Project: IEEE P802.15 Working Group for Wireless Personal Area Networks (WPANs)

Submission Title: [proposed resolutions about comments CID 244 and more]

Proposed resolutions of CID 664 and more

(664, 704, 710, 711, 712, 483, 691, 700, 703, 555, 557, 561)

CID 450 for dimming

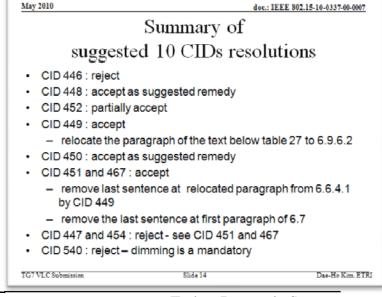
CIE	Name	Clause	Subclau se	Pag e	Line	Comment	SuggestedRemedy		
450	R. Robe	ert6.6.4 1		52		Make changes to the text	Change "After communications, sequent frames" with "After link establishment, sequent frames"	huna i	review and dis n the near futu ference doc 1 r0

- Change "After communications, sequent frames ..." with "After link establishment, sequent frames ..."

- We've discussed it in Beijing meeting like below 10/337r0.
- **❖** So, based on doc.10/337r0
- Accept
- refer the slide 13 in 10/337r0

• CID 450 : Accept as suggested remedy
